**CHANDIGARH
HOUSING BOARD**
A CHANDIGARH ADMINISTRATION UNDERTAKING

No.CHB/EO/DY.EO-I/2023/ 739

The allottee / occupant
House No. 886-1, Sector 41-A
Chandigarh

Subject : Additional construction / violations in Duplex Flats in Sector 41-A, Chandigarh.

FIRST FLOOR PLAN

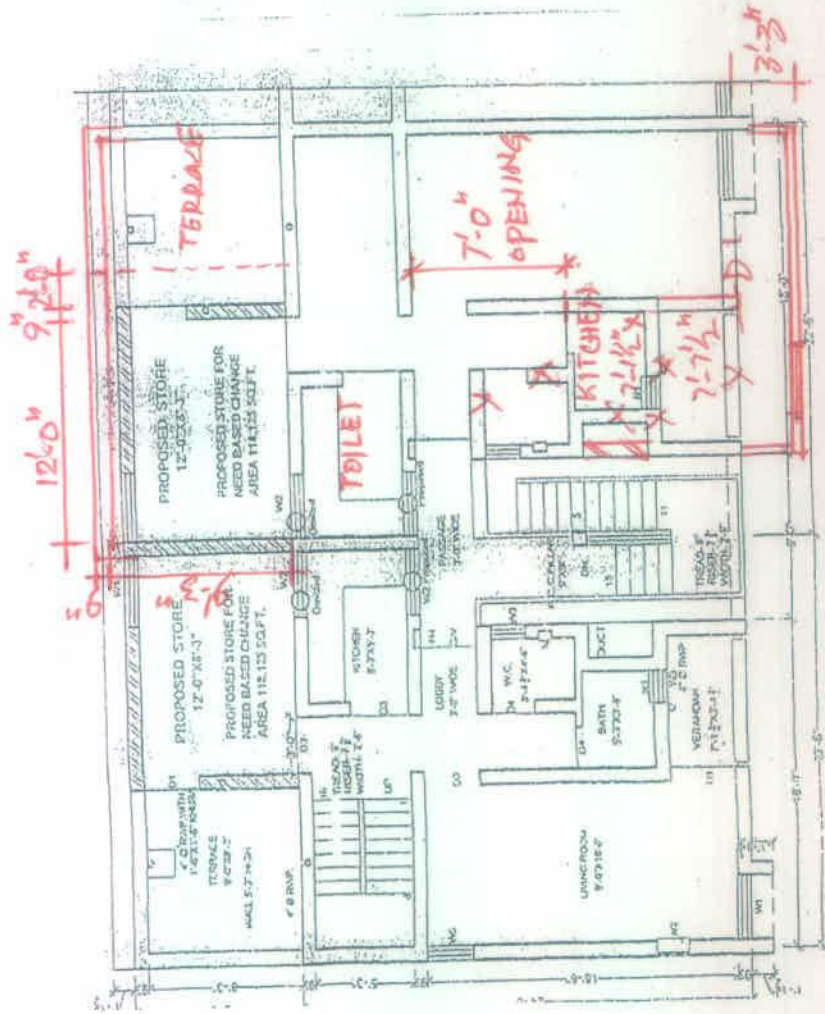
... .. room at first floor is not.
